Technical Bulletin / Safety Alert

Unique ID No: DES2011-TBSA-06

Subject: JUG-A-0 UL/UV Diesel Particulate Matter Filter Fire – Incident Notification

Applicable to: All JUG-A-0 UL/UV Diesel Engine System Design Registration Nos.
MDR074246DES, MDR074246DES-1 & MDR114991DES

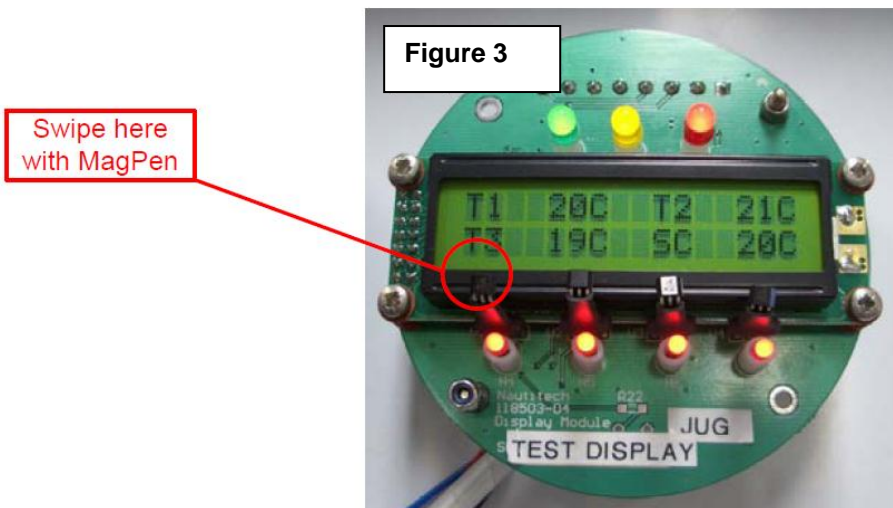
- All JUG-A-0 UL/UV equipment owners and end users to inspect machines for correct operation of shutdown systems and correct circuit board installation as per following procedure.
- The simplest method for checking the correct circuit board is installed to the machine is to power up the display unit and using magnetic pen swipe the far left key and observe that the screen will display the temperatures at T1, T2, T3 and SC (supercharger), which identifies that all sensors are operating correctly (Figure 3).
